**REMARKS**

Favorable reconsideration of this application is requested in view of the foregoing amendments and the following remarks. Claims 1-2, 5-7, 9-15, 17-21, 23-27, 29-30, 32-35 and 37-39 are pending in the application. Claims 3-4, 8, 16, 22, 28, 31 and 36 are canceled without prejudice or disclaimer.

FIG. 1

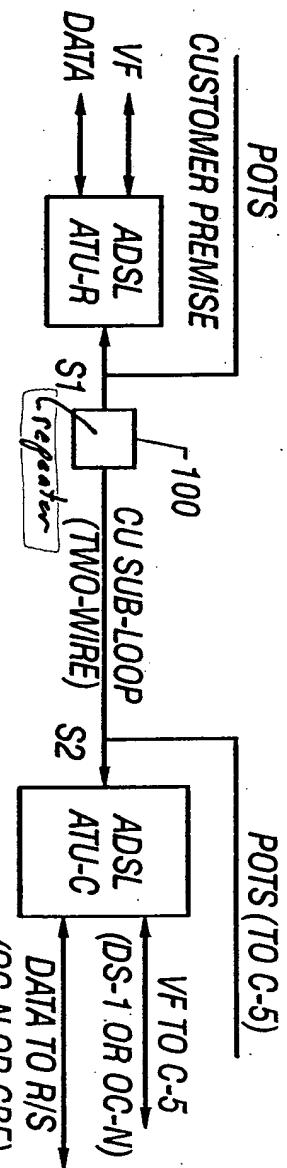
At page 2 of the Action, the Examiner objects to the drawings. The Examiner's careful consideration of the drawings is appreciated. Applicant submits herewith one copy of two (2) sheets of drawings that overcome the objection to the drawings as set forth by the Examiner by

adding text labels (i.e., "repeater") to blocks 100, 200 and 300. Support for this change to Figs. 1-3 is found at line 6, page 7; lines 21 and 27, page 8; and line 28, page 9 of the specification as originally filed. Applicant requests that the Examiner approve the substitute drawings and withdraw the objection to the drawings. Marked-up versions of the substitute sheet(s) of drawings are attached hereto with the change(s) shown with red ink markings. Upon the Examiner's approval and allowance of this application, Applicant will submit formal drawings that incorporate the proposed change(s).
